Access Compliance Report

Public Rights-of-Way

(Curb Ramps)

Intersection ID: 52313	Main Street: LUPINE_CT	Cross Street: SNOWBELL_CT	Location: NW
ADA ID: EC732D755E44	Ramp Type: Perp	Initial Pass/Fail: Pass	Overall Compliance: No
			Severity Score: 20.25

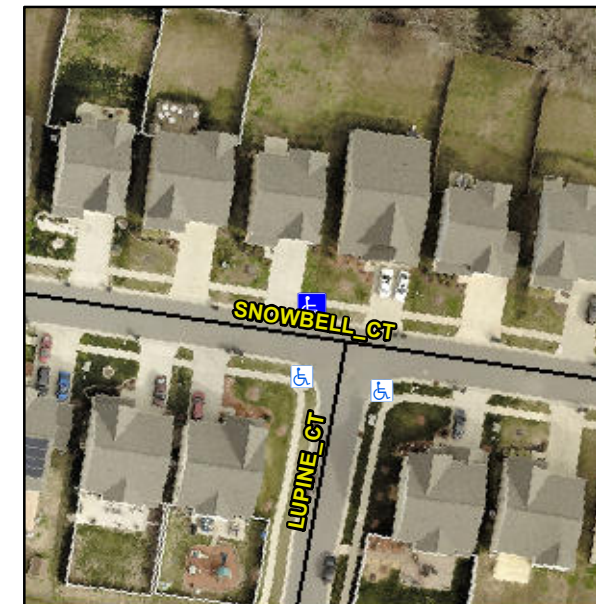
**Not Found, R304.5.3, R304.2.1,
R305.2, R302.7, R302.7.2, R304.5.4**

Compliance	Description	Data	Compliance	Description	Data
N/A	Ramp Length (in)	68.5	Yes	Ramp Slope (%)	5.2
Yes	Ramp Width (in)	48.0	No	Ramp XSlope (%)	2.8
N/A	Flare Type LT	Sloped	N/A	Flare Type RT	N/A
N/A	Flare Slope LT (%)	2.6	N/A	Flare Slope RT (%)	9.7
N/A	Flare Traversable LT?	No	N/A	Flare Traversable RT?	No
No	Landing Length (in)	47.5	Yes	DWS Provided?	Yes
Yes	Landing Width (in)	77.0	Yes	DWS Contrast?	Yes
Yes	Landing Slope (%)	1.0	Yes	DWS Length (in)	24.0
Yes	Landing X Slope (%)	0.2	Yes	DWS Full Width?	Yes
N/A	Landing Curb? (Y/N)	No	No	DWS Offset (in)	4.0
N/A	Shared Landing?	No			
No	Gutter Ponding?	Yes	No	Gutter Slope (%)	5.1
No	Gutter Lip Ht (in)	1.8	Yes	Gutter X Slope (%)	2.1
N/A	Painted X Walk1?	No	N/A	Painted X Walk2?	N/A
	X Walk 1 Direction	To SW		X Walk 2 Direction	N/A
N/A	X Walk 1 Width (in)	N/A	N/A	X Walk 2 Width (in)	N/A
	X Walk 1 Slope (%)	3.9		X Walk 2 Slope (%)	N/A
	X Walk 1 X Slope (%)	2.4		X Walk 2 X Slope (%)	N/A

**Remove & Replace Entire Ramp.
Remove & Replace Gutter.**
